Addendum No. 2
October 23, 2025

Project: Beresford High School Addition
Beresford, South Dakota
Project #2979

Architect: Architecture Incorporated

REFLECTED CEILING PLAN - UPPER LEVEL AREA B

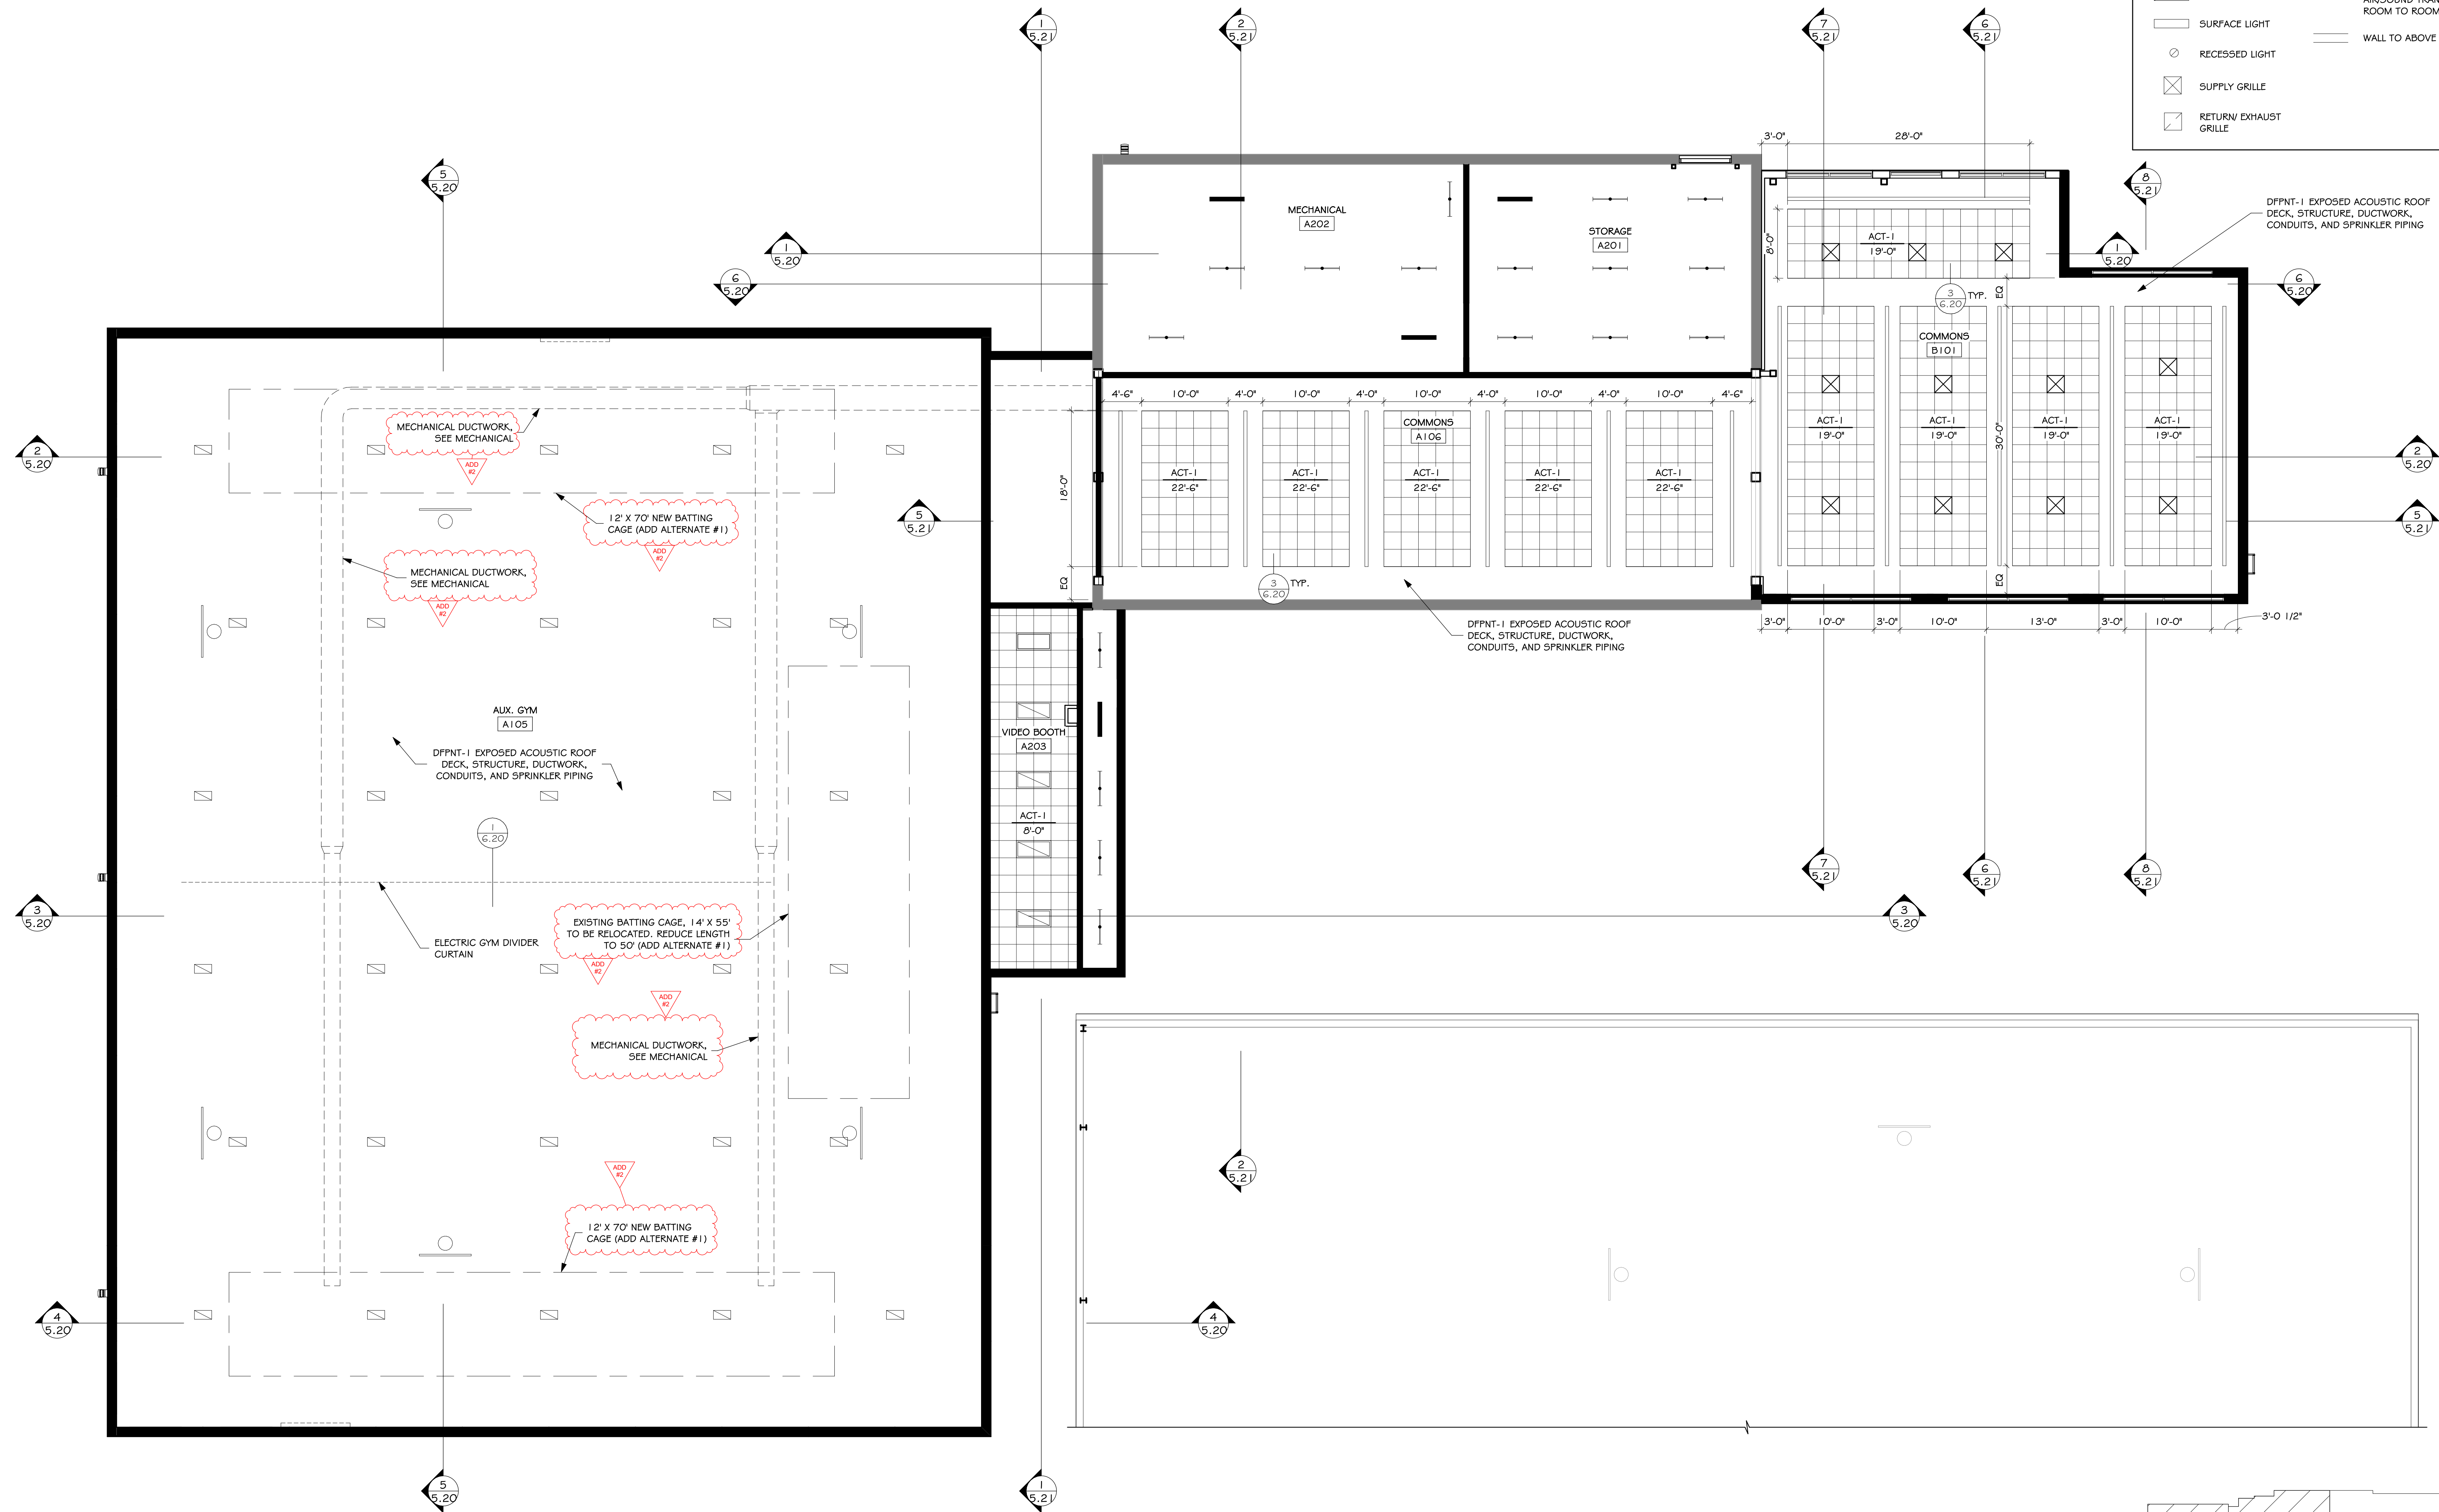
- a) See attached *revised* Sheet 6.11, *revision* dated 10-23-2025, for location of light fixtures, ductwork and batting cage; not shown in original drawing.
